3.1 15 Broadway, Camberwell - Extension to House in Heritage Overlay

Application no.:	PP21/1140
Responsible director:	Scott Walker, Director Urban Living
Authorised by:	David Cowan, Manager Planning and Placemaking
Report officer:	Damian Bu and Elizabeth Spanjer, Urban Planners

PLANNING ASSESSMENT REPORT

Partial demolition and construction of alterations and additions to an existing dwelling and the demolition of an additional dwelling on the lot in a Heritage Overlay

Figure 9 - MMBW Plan 1882.

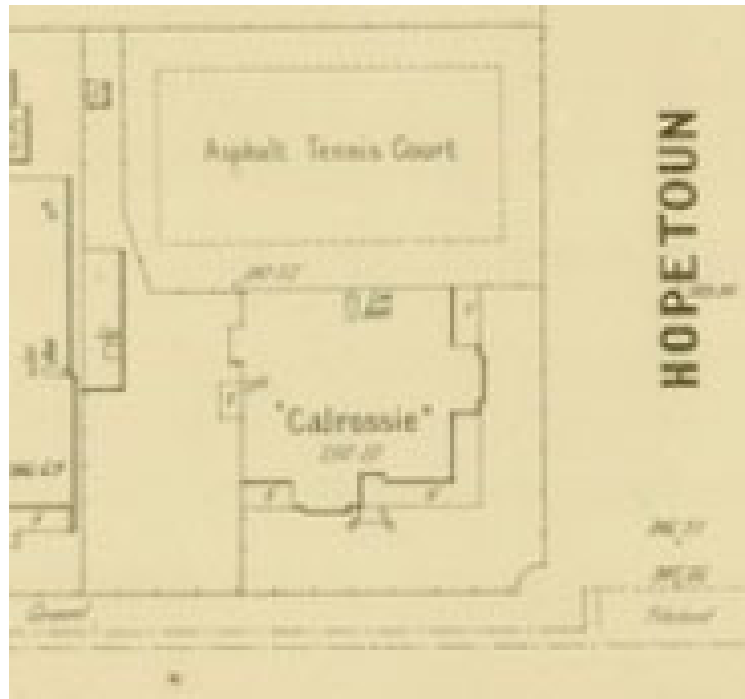
Council's Heritage Advisor utilised the *MMBW Plan* (see, **Figure 9**)¹ for the property to determine the original and later fabric of the heritage dwelling. The western balcony and projecting gable (as shown at **Figure 8**) are notably absent on the *MMBW plan*. Meaning, despite the highly sympathetic presentation of this elevation, it is evident that is a later addition to the site and is not of heritage value.

Figure 10: Existing northern elevation, demonstrating extent of proposed demolition in a hatched overlay.

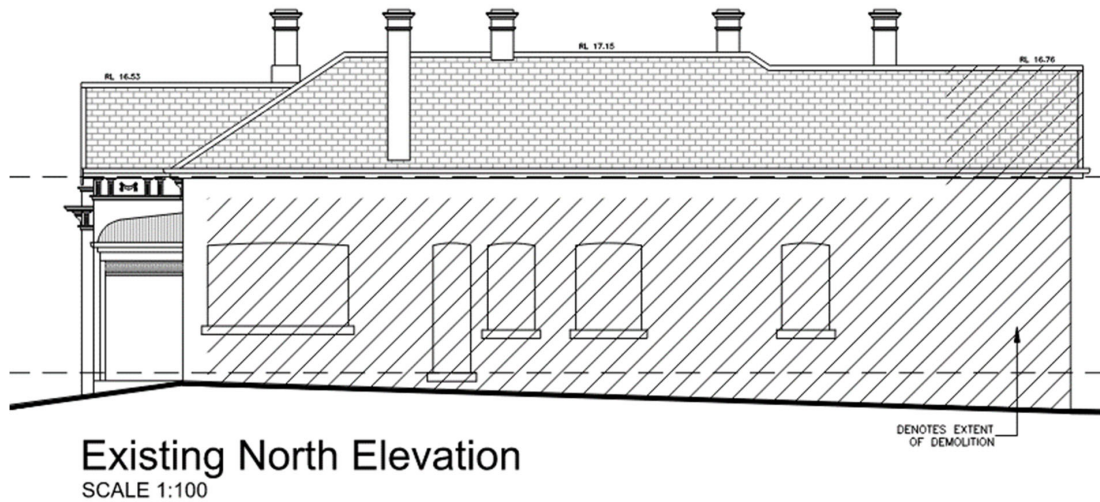
Council's Heritage Advisor is supportive of the extent of proposed demolition to the northern wall (See, **Figure 10**) given the limited visibility from the street and the altered state of the wall. Photographic evidence (See, **Figure 11**) presented to Council's Heritage Advisor reveals substantial alterations to the northern wall detailing the combination of altered openings, down pipes, new brick mortar and windows. On this basis, the demolition of the northern wall is supported given the demolition will not adversely affect the cultural heritage significance of the existing building or diminish the long-term conservation of the building having regard to Clause 15.03-1L (Heritage Policy), which permits "*partial demolition of 'contributory' heritage places for the purpose of additions and alterations only if the partial demolition... will not adversely affect the cultural heritage significance of the precinct...*".

- Demolition Plan amended to include notations specifying the retention of all existing chimneys to the existing dwelling;
- Roof plan amended to include notations specifying the retention of all existing chimneys to the existing dwelling; and
- Demolition Plan amended to include dimensions to the extent of proposed demolition to the existing dwelling.

Figure 12: Proposed Ground Floor Plan, required setbacks marked up by Council in red. North to the right of plan.

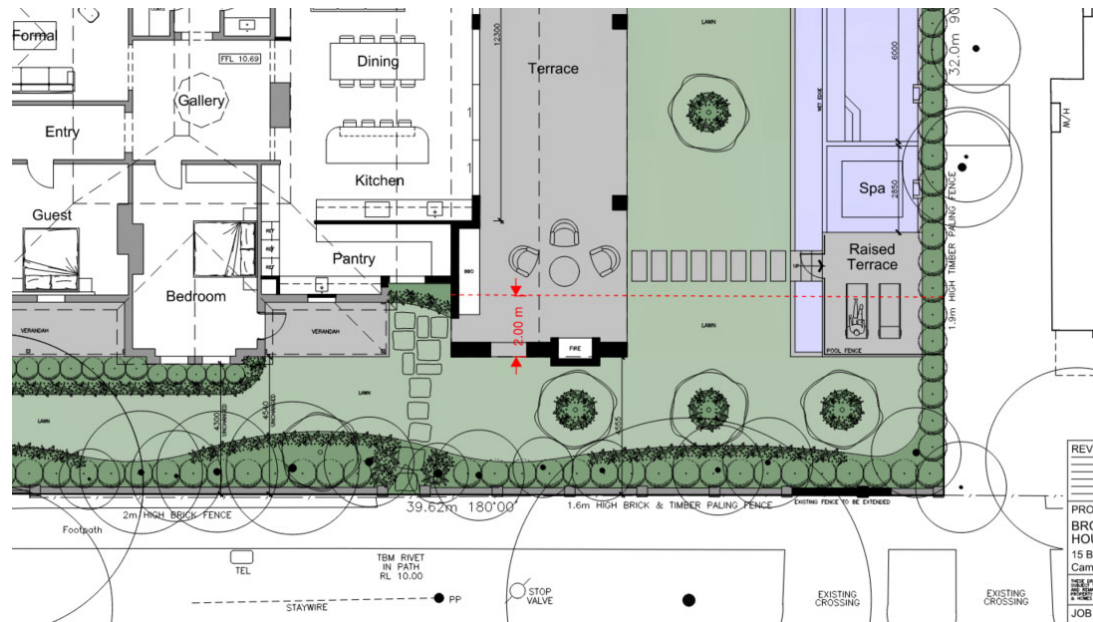
A terrace is proposed to be hosted off the northern wall of the original dwelling. The terrace will run east-west on the site and will align with the original verandah hosted off the eastern elevation. Council's Heritage Advisor has recommended the new terrace be setback at least 2.0 m in from the existing eastern boundary. The setback requirement is demonstrated at **Figure 12**.

The increased setback of the terrace from the eastern boundary will provide a clear delineation between old and new fabric, whilst also providing breathing room for the original architectural details along the northern and eastern elevations.

- b. The external eastern wall of the Terrace (including the chimney) setback an additional 2.0 m from Berwick Street.
 - c. Material/Finish No. 7 (dark grey render) as noted on the plans revised to either a mid-grey or lighter finish to the satisfaction of the Responsible Authority.

Above - Proposed Ground Floor Plan, with Council markups.

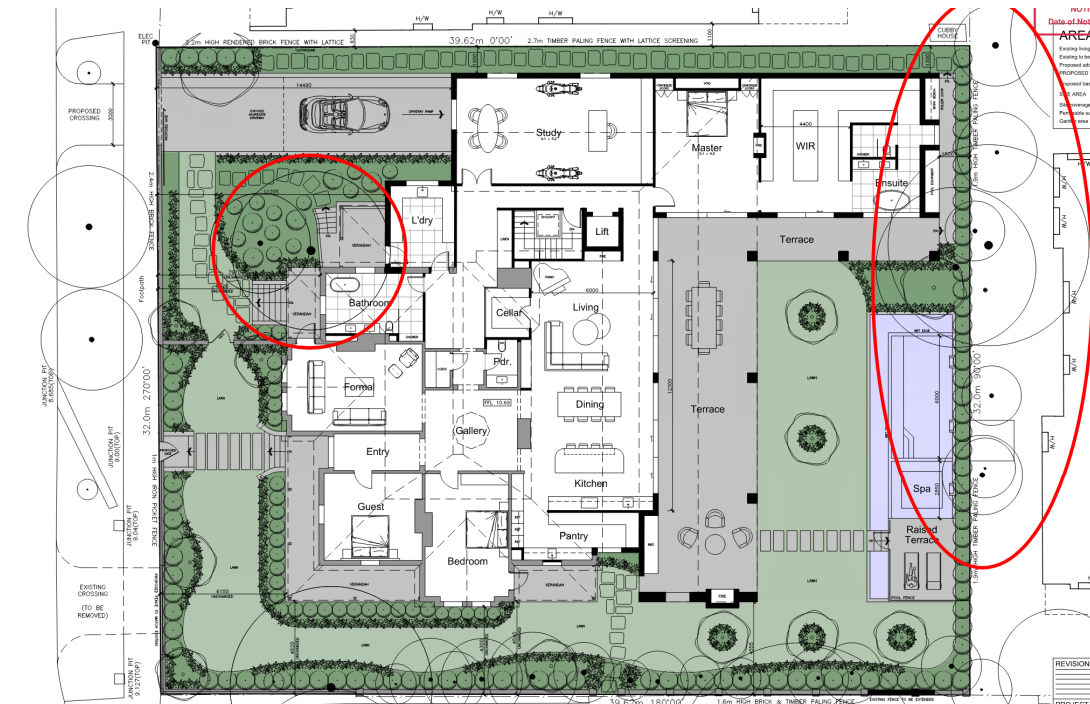
The application was verbally referred to Council's Arborist on 01 August 2022, who advised Tree Local Law Permits are required prior to the commencement of construction, for the trees circled red below.
